PHAP26-00039

ITEM #3

Certificate of Appropriateness for alterations to rear facade including the removal and replacement of a balcony and porch

REAR ELEVATION –
CONCEPT SKETCH

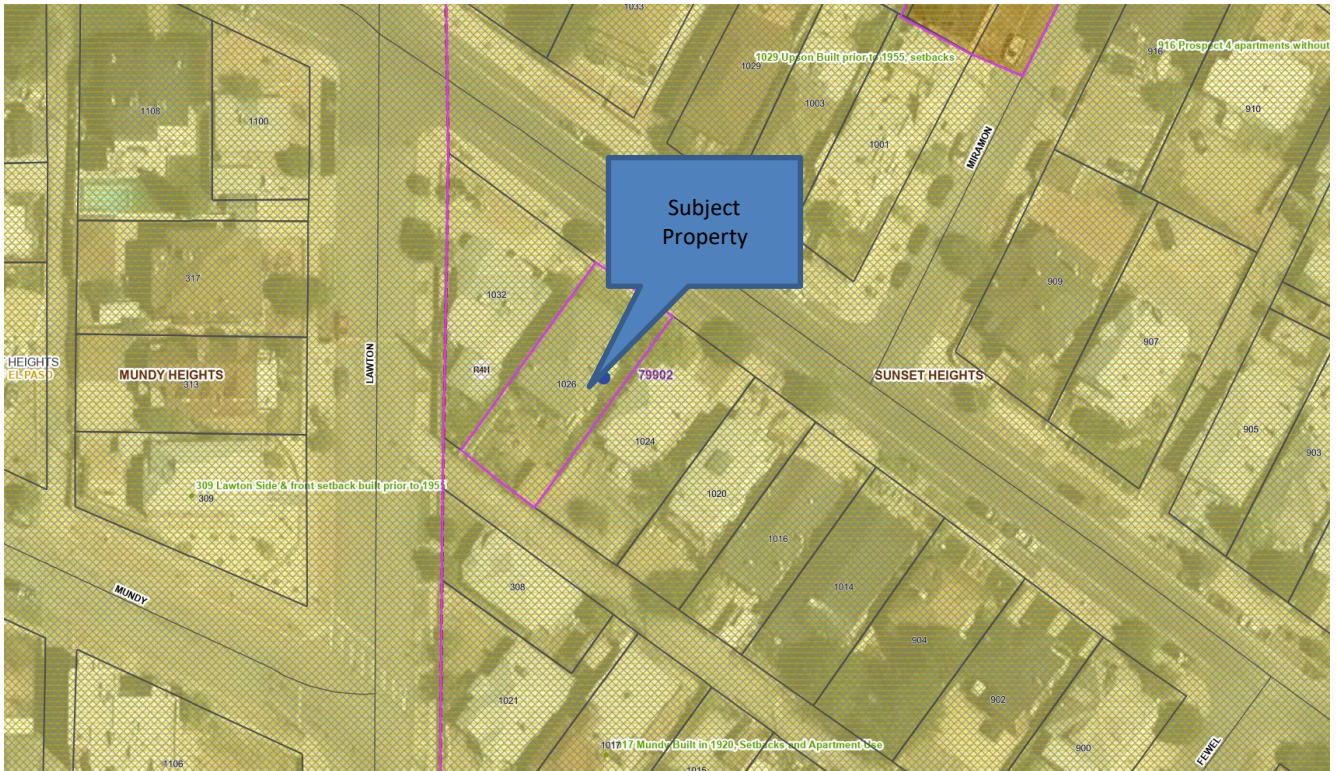
The modifications are that the applicant submit accurate plans, elevations, and sections of the proposal to the Historic Preservation Office prior to getting permits; that the roof not be changed; and that the transom windows above the doors on the rear façade be retained.
